ROBINSON NUCLEAR PROJECT

PLANT MODIFICATION M-958

ADD AUTO START TO "B" SI PUMP

SAFETY EVALUATION FOR M-958  
"ADD AUTO START TO 'B' SI PUMP"

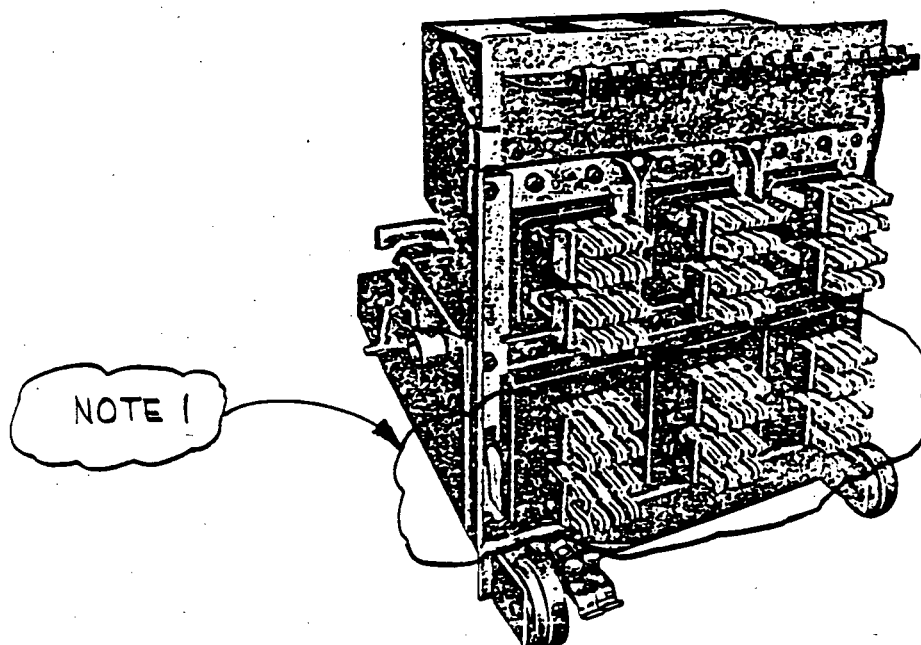
- 5.9.1      Replace the current sensors on Breakers 52/22B and 52/29B as  
            detailed in Drawing SK-958-Z-7028.

- I. REPLACE EXISTING 3000/5 AMP CURRENT SENSORS WITH NEW 1000/600/5 AMP SENSORS.  
(ITEM 9 OF BILL OF MATERIAL)
